Auckland Regional Landfill

Compiled further information responses

Prepared for
Waste Management NZ Ltd

Date
March 2020

Figure 1.1: Hydraulic Conductivity of GCL as a function of free swell of bentonite from Kolstad et al.⁷

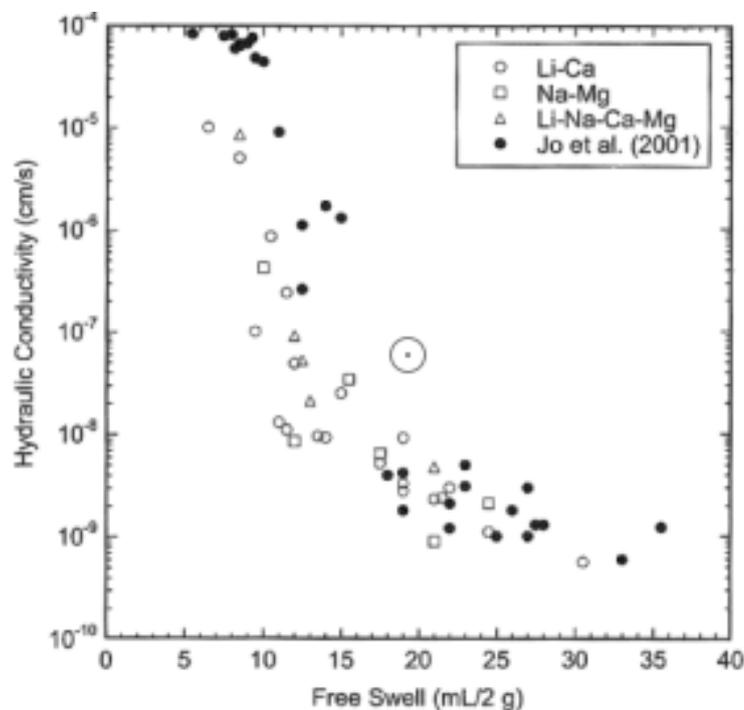
15 *Actual effectiveness of the liner is also related to liner design, liner selection, and liner suitability for the site conditions and waste type/leachate chemical composition. Provide further information / supporting evidence on the effectiveness (over entire life-span) of the proposed liner with respect to:*

The first two questions above related to the compatibility of the GCL with the groundwater chemistry and leachate chemistry. The background to this is that most GCLs are manufactured using sodium bentonite. Sodium bentonites are prone to cation exchange when permeated with solutions containing divalent or trivalent ions, for example Ca²⁺, which can lead to increases in the permeability of the GCL. This can be a significant factor when a GCL is used to contain waste that

produces particularly aggressive leachate. Johns and Shamrock⁶ provided a literature review of research into this matter and described further experimental work to provide a correlation between the relatively simple swell index test (ASTM D 5890) and permeability. Determining the effects of cation exchange by permeability testing can be difficult to achieve and must be undertaken over a long period of time. The swell index test shows a good correlation with hydraulic conductivity, with the conductivity not affected to any great extent for a swell index greater than approximately 15 mL/2g, refer Figure 1 below.

As the ARL is not yet operational it is not possible to undertake any testing using actual leachate from the landfill. Similarly, we do not know precisely what GCL will be used, although it will be specified in accordance with standards current at the time, e.g. GRI-GCL3. However, we have provided leachate data for Redvale Landfill to Geofabrics in Australia (who provide Elcoseal GCL). Geofabrics have a database of test results for their products for a range of leachate strengths and have provided the report included in Appendix A.

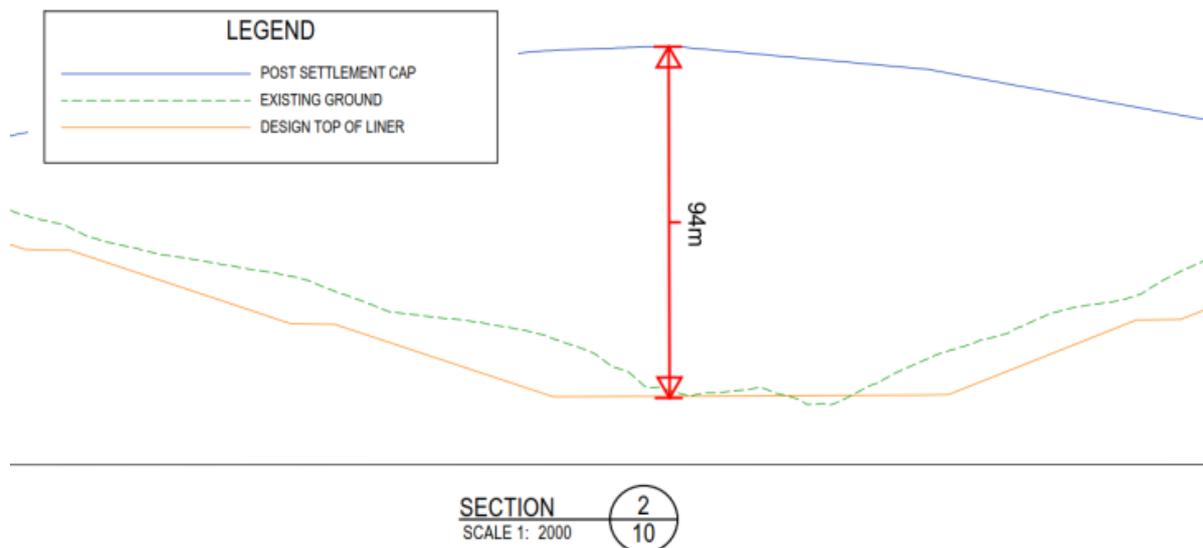
8 *A number of parameters and model input assumptions within the RBCA model require further explanation on their; appropriateness, level of conservatism, and sensitivity - with respect to the hydrogeologic setting and the output results. Specific parameters for further explanation:*

Depth to Water Bearing zone – This parameter is derived from the maximum design thickness of the landfill, which is estimated to be 94 m thick (refer figure below, and Figure ENG-16, Cross section 2).

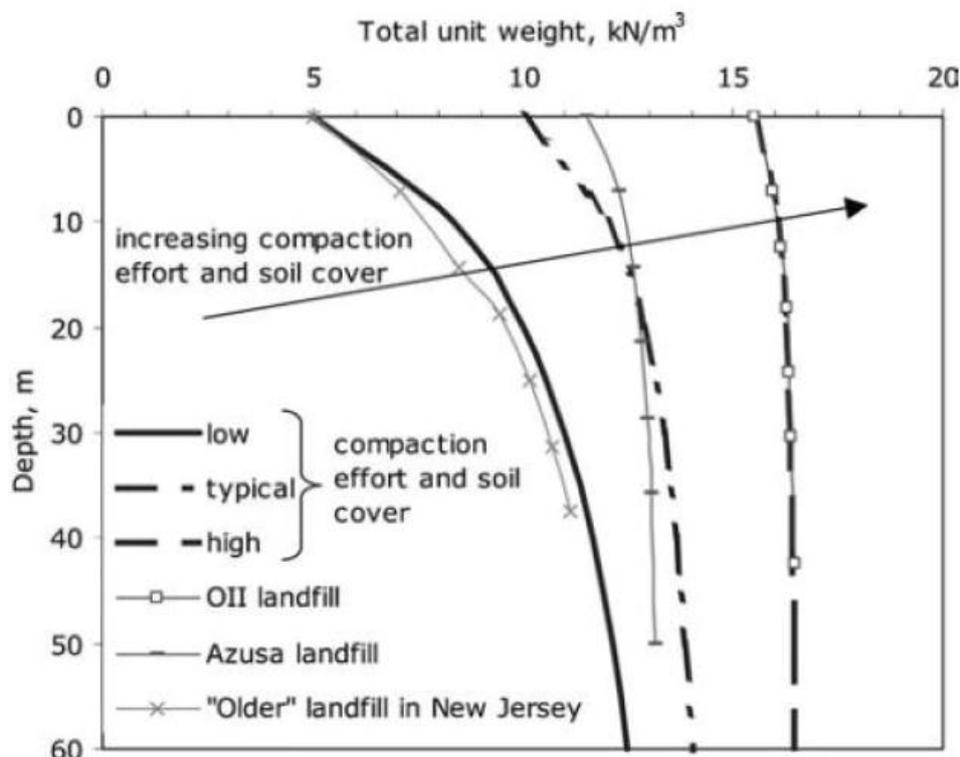
44c Table 7.1, properties of landfill components. What was the source of information to generate these properties?

The material parameters for refuse material is highly variable due to compaction, depth and composition of the refuse. We have adopted the unit weight of 14 kN/m³ for refuse with typical compaction effort and soil cover based on Figure 11 from Ed Kavazanjian et al. (1995) provided below.
